**Agricultural wheeled tractors —
Rear-mounted three-point linkage —
Categories 1N, 1, 2N, 2, 3N, 3, 4N and 4
AMENDMENT 1**

Reference number
ISO 730:2009/Amd.1:2014(E)

AMENDMENT 1

Figure 2 — Distance from PTO to lower link points

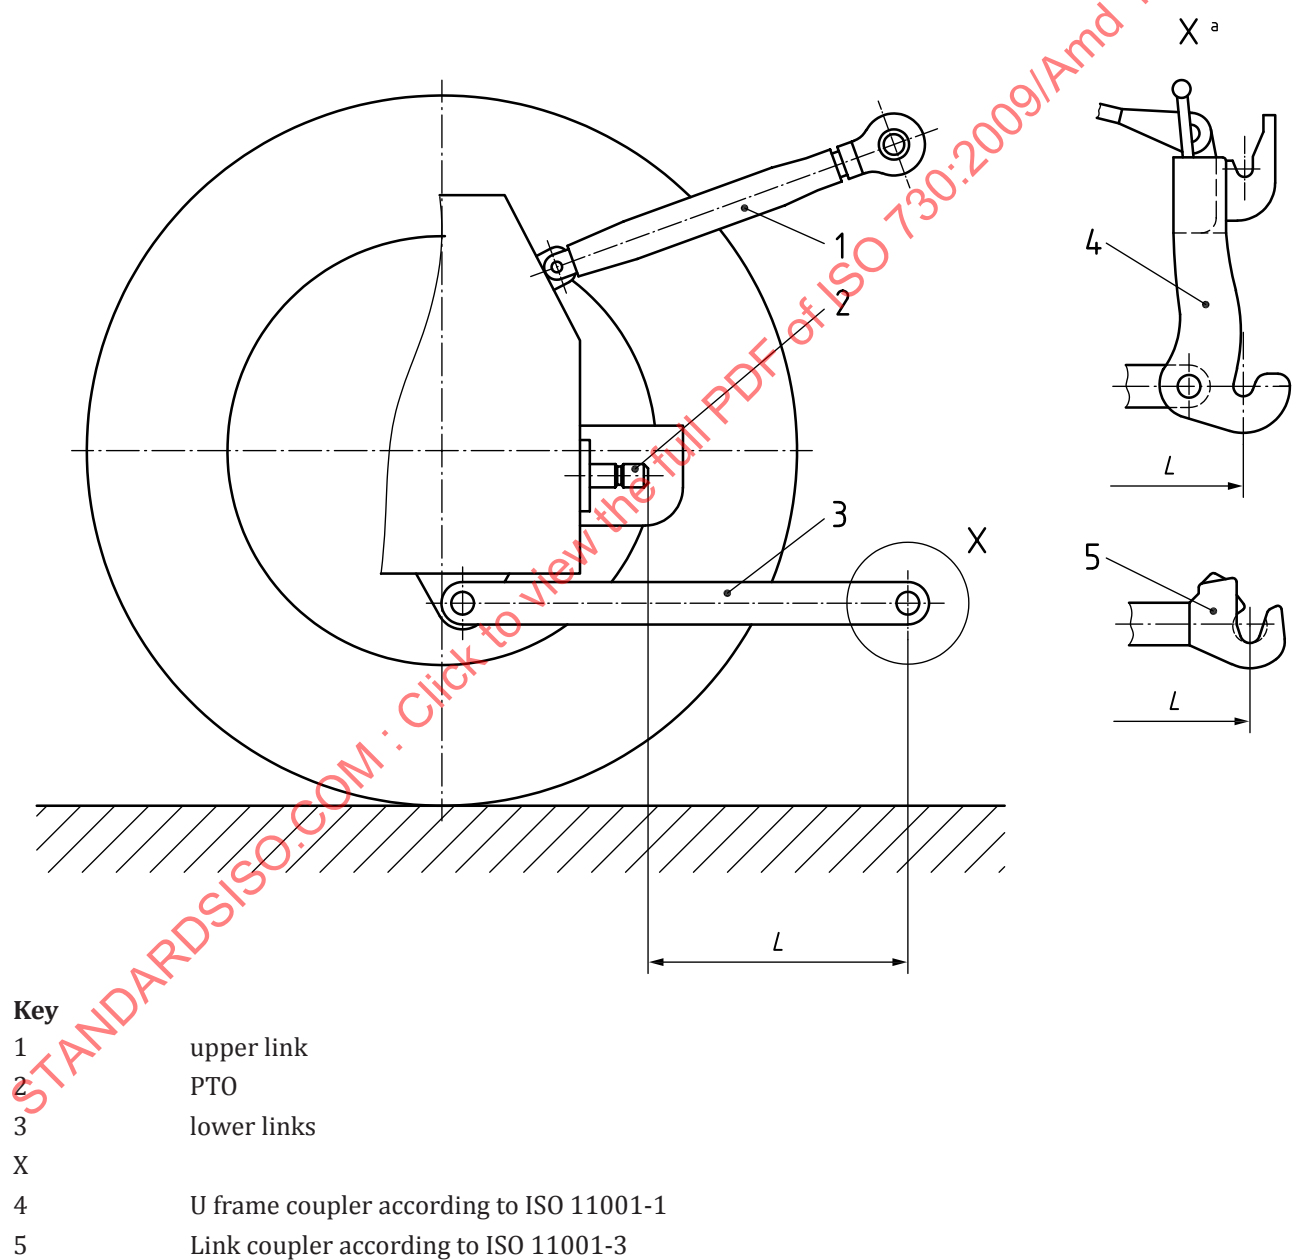
Page 7, [Figure 2](#)

Replace the present [Figure 2](#) by the following [Figure 2](#):

NOTE Dimension L is given in [Table 2](#).
